To: All Vendors  
From: Seletha R. Thompson  
Purchasing Analyst  
Re: **Addendum #1 for RFP 21305 - Luis Munoz Marin**

# **ADDENDUM**

***Cleveland Metropolitan School District***  
**Luis Muñoz Marín Elementary School**  
**AC-5 RTU Replacement Project 2020**

July 20, 2020

DRAWING NUMBER:  
**A.01**  
PAGE: 4 of 10

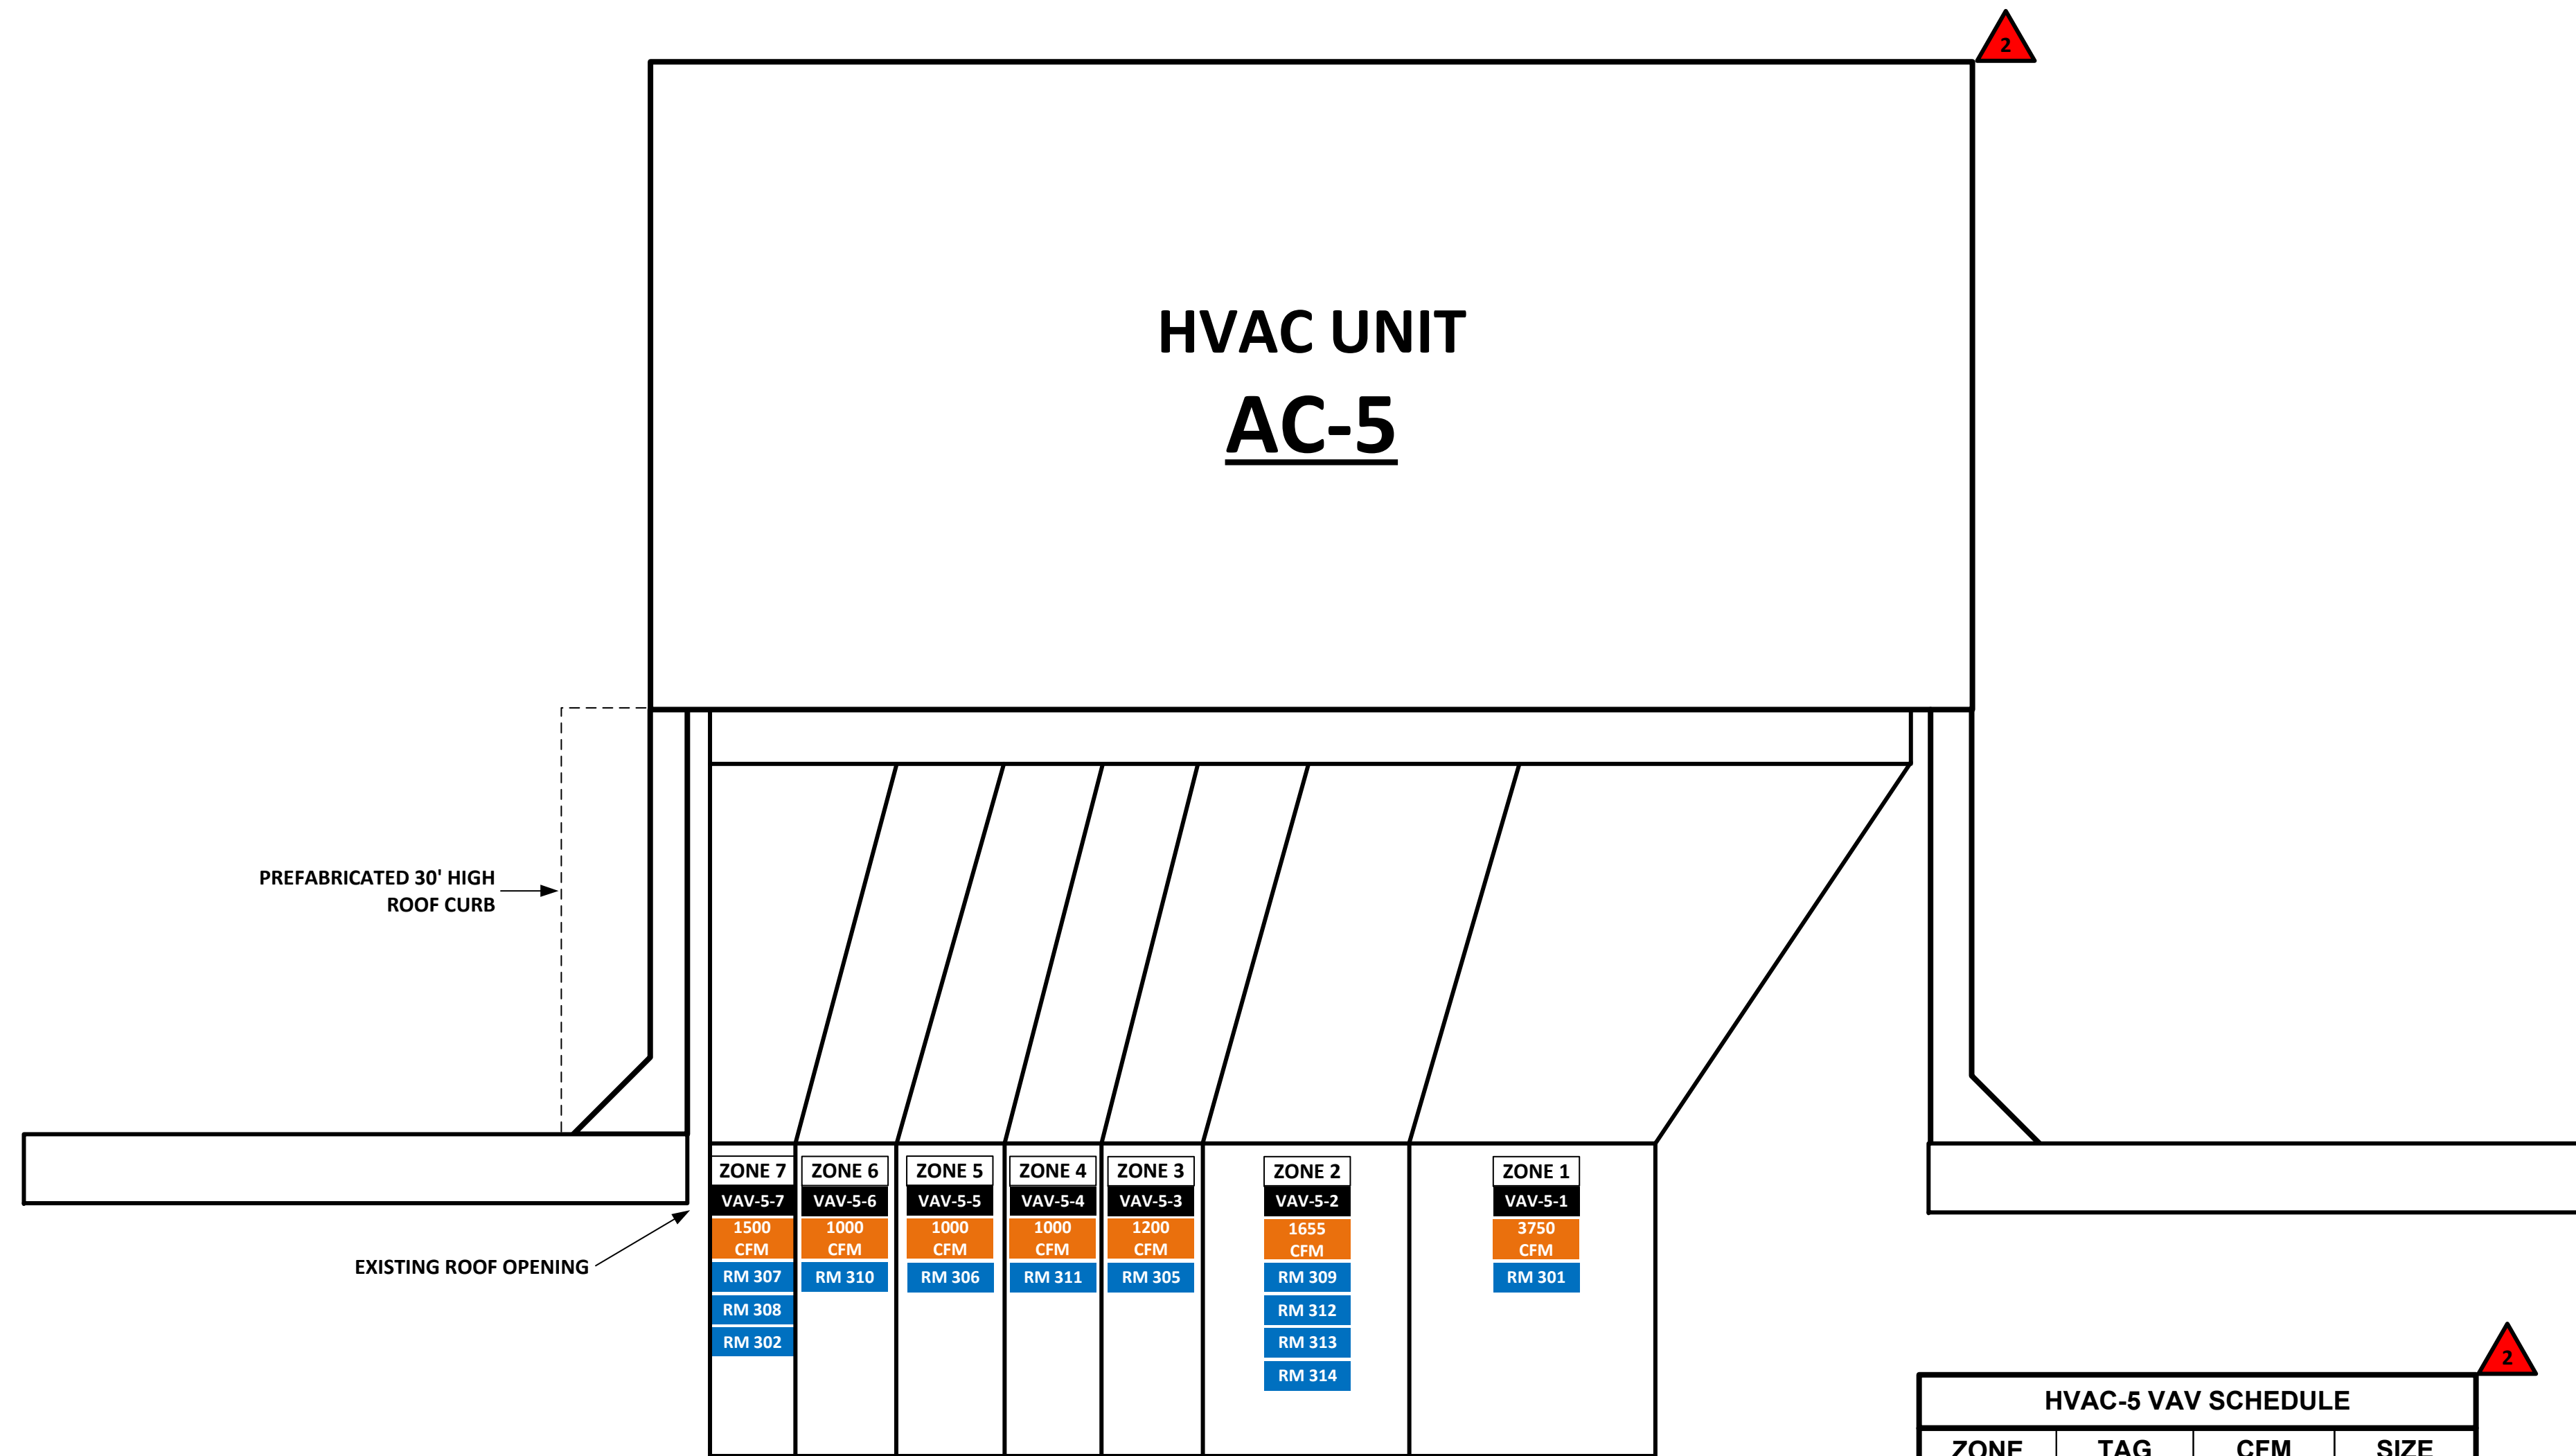
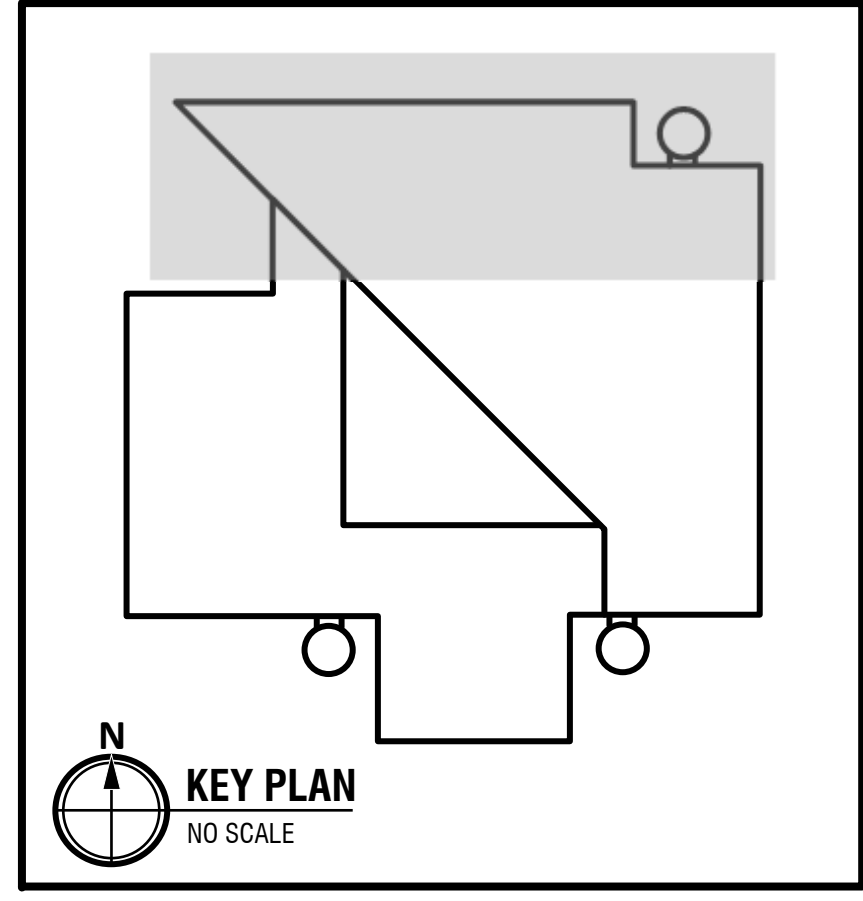
- Sheet M.01 (Page 7):
  - Added note to refer to added sheet SC.01 for revised zone CFM totals and VAV schedule.
- Sheet M.02 (Page 8):
  - Revised HVAC Zone Designations in accordance with sheet SC.01.
- Sheet A.01 (Page 9):
  - Revised Lighting Zone Designations.
- ADDED Sheet SC.01 (Page 10):
  - Contains RTU HVAC Unit AC-5 zoning schematic, CFM totals and revised VAV schedule.

DRAWING NUMBER:  
**SC.01**  
 PAGE: 5 of 10

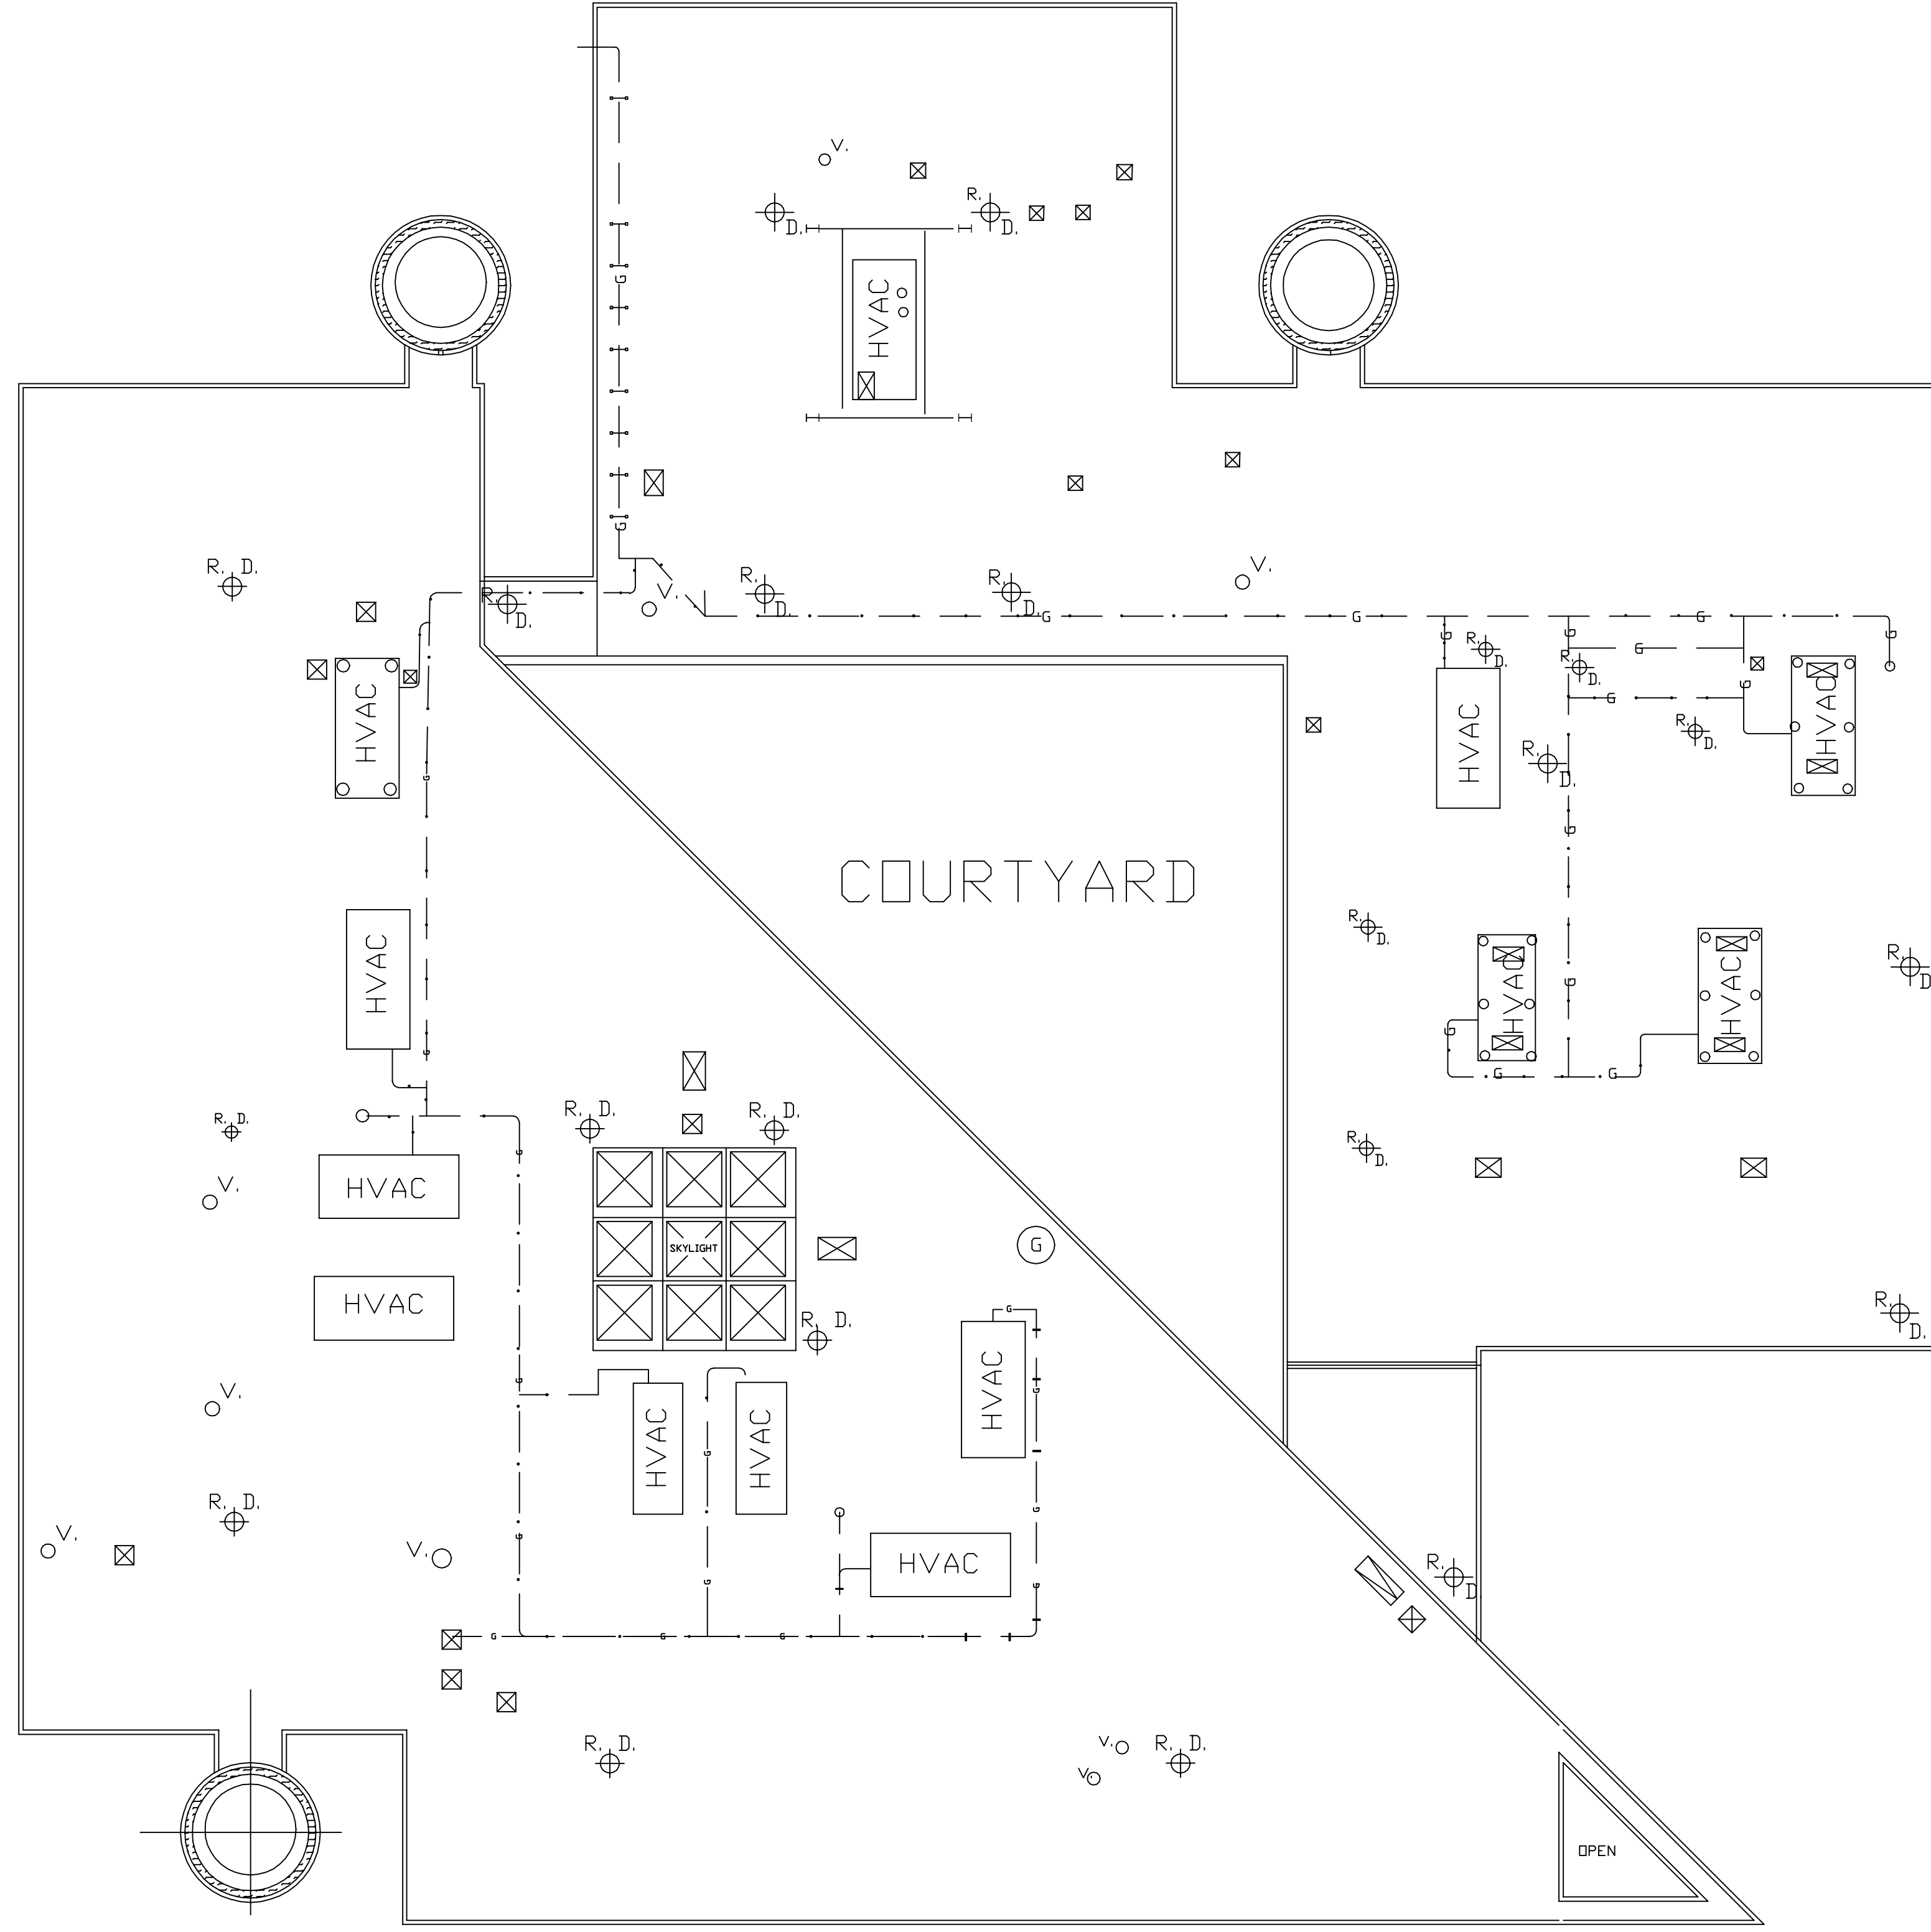
HVAC-5 VAV SCHEDULE			
ZONE	TAG	CFM	SIZE
1	VAV-5-01	3750	VERIFY
2	VAV-5-02	1655	VERIFY
3	VAV-5-03	1200	VERIFY
4	VAV-5-04	1000	VERIFY
5	VAV-5-05	1000	VERIFY
6	VAV-5-06	1000	VERIFY
7	VAV-5-07	1500	VERIFY
<b>TOTAL:</b>		11105
